CALICO SOLAR POWER PROJECT

DPW CONCERNS REGARDING:

Supplemental Staff Assessment, Part II
September 13, 2010

Roger G. Hatheway Principal Investigator Cultural Resources Specialist DPW

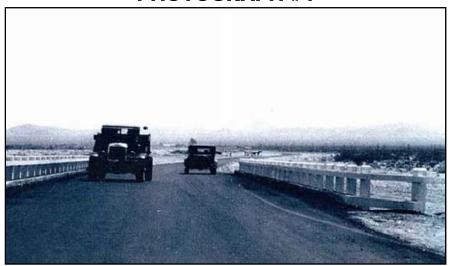
The typical desert bridge being reconstructed consists of 19-foot spans on timber pile bents. The deck system is timber stringers with laminated timber floor and asphalt surfacing of varying thicknesses. Under the method of reconstruction which has been adopted, the surfacing is first removed and the deck exposed, defective stringers and caps are replaced and laminated floors are tightened and respiked. The bituminous surfacing is replaced with a concrete slab and the old timber rail is replaced with steel rail or a new timber rail so constructed as to increase the roadway width to 26 feet between curbs.

In summary, the reconstruction of all of the Route 66/National Old Trails Road timber trestle bridges during the period extending from 1944 to the mid-1950s resulted in substantial alteration to the original architectural and technical (structural) integrity of each of the bridges. Alterations made to the majority of NTH timber trestle bridges include the widening of each bridge approximately three feet to a width of 26 feet between curbs, removal of original guardrail and replacement with a new steel or new timber railing, and addition of metal approach guardrails. The following photographs clearly illustrate the manner by which various physical alterations made to all Route 66 bridges have compromised the collective visual and historical integrity of the bridges.
